Mr. Peter Kivett  
Office of Defects Investigations  
1200 New Jersey Ave SE  
Washington, DC 20590

Please find below and attached our response to your request for information regarding PE13-008. Enclosed is a CD which contains data detailing our production, complaint and warranty information regarding the subject vehicle. Please note that the production data is sorted by DOB (date of build). All vehicles built after 6/28/2012 were produced with an exhaust extension downturn and a warning sticker in the compartment per Manning bulletin MEBULL0121 (attachment 1).

Bulletin: MEBULL0121

**Subject: Exhaust Extension and Decal**

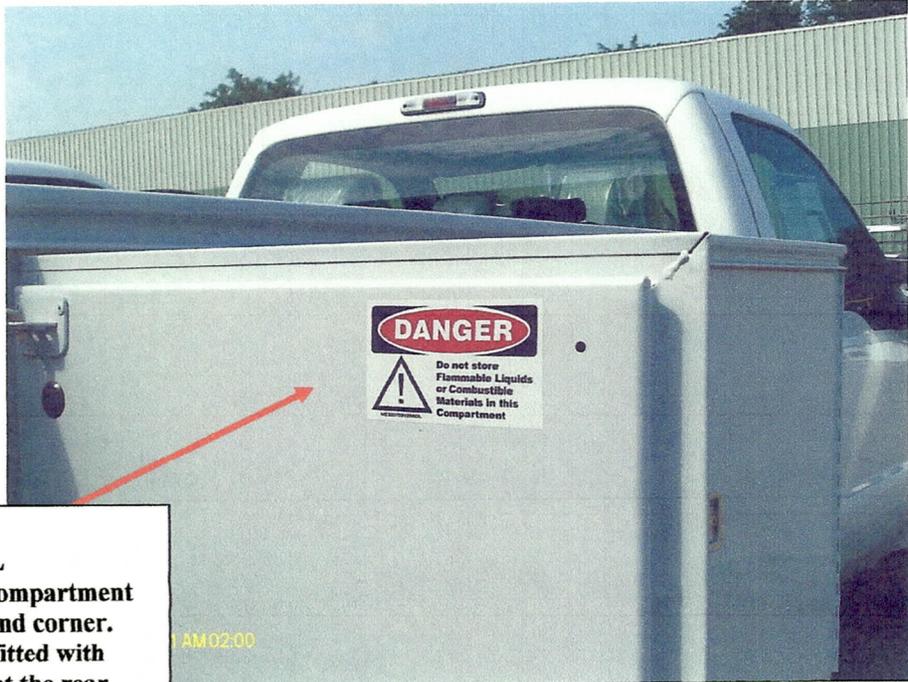
In review of this application we are finding that the exhaust spray on some of these vehicles was discoloring paint and/or primer in the lower floor area of the rear compartment. Also in some cases was damaging the plastic drain plugs in these compartment floors.

Effective immediately all Ford F350-550 Super Duty Chassis Cab DRW Gas Engines with Service Body Applications will require the installation of exhaust extension #K3512EXA. Attach to end of OEM exhaust tail pipe using #RB35ZN 3.5" U-bolt clamp. The installation of this extension is to extend and redirect the exhaust spray down and away from service body compartment floor. Install Danger Decal #ME32070312SBDL to upper right hand corner inside compartment door above rear exhaust pipe and extension.

**#RB35ZN 3.5" U-Bolt Clamp**

**#K3512EXA 3.5" x 12" Exhaust Extension**

**Danger Decal**  
**#ME32070312SBDL**  
**Install Inside rear compartment door upper right hand corner.**  
**Note: If body is up fitted with two compartments at the rear, decal must be installed in the compartment closest to the truck exhaust pipe.**

Figure 7 – Maximum temperature achieved during test for each thermocouple (both tests shown).

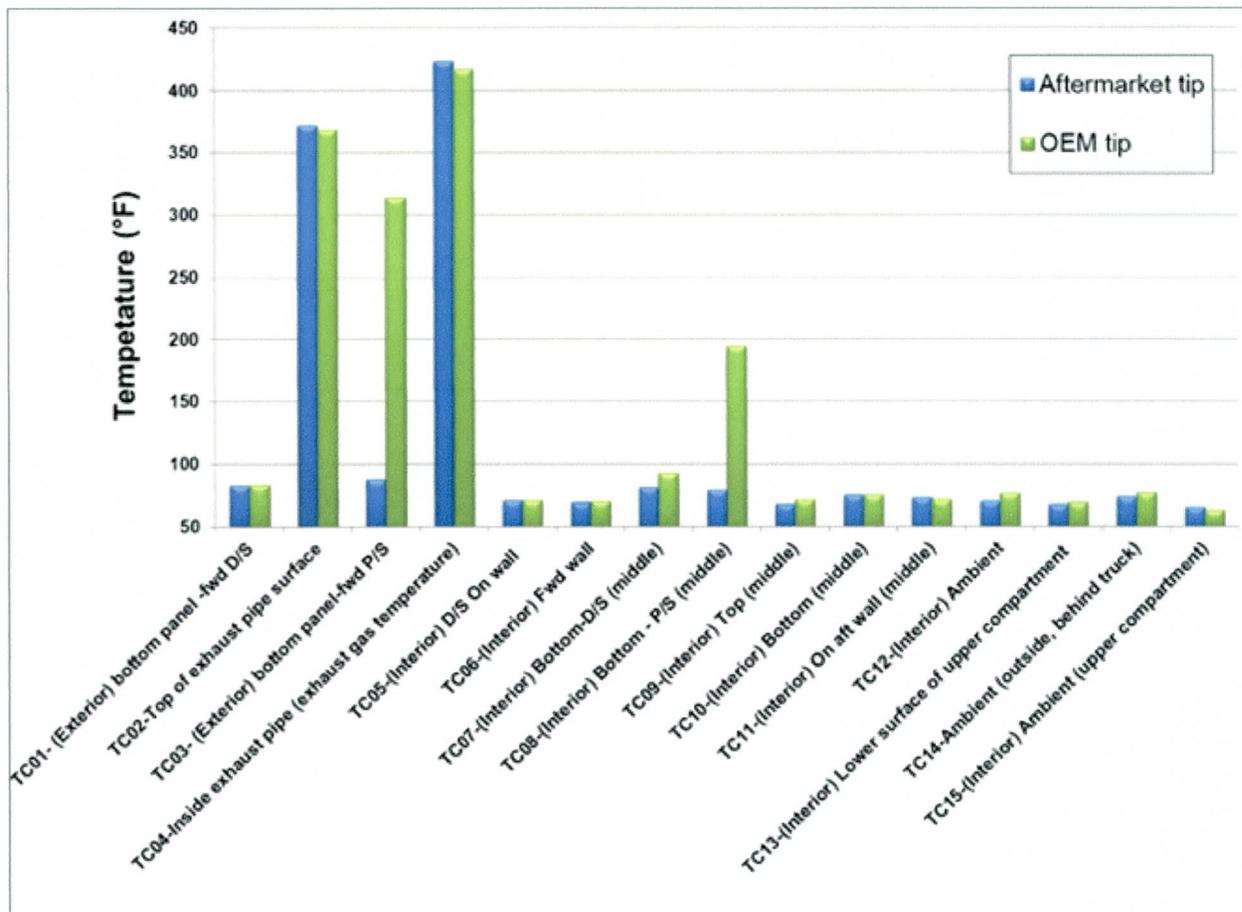
A road test was performed for each exhaust configuration (aftermarket tip and OEM tip – Figure 4). Prior to each road test, the vehicle was started and allowed to warm up for approximately five minutes. The road test route (Figure 5) was 12.5 miles in length and included both highway and street driving. After the road test, the vehicle was allowed to idle for approximately ten minutes. Temperature data were collected throughout. Weather conditions for both tests were sunny with an air temperature of 55-65 °F.
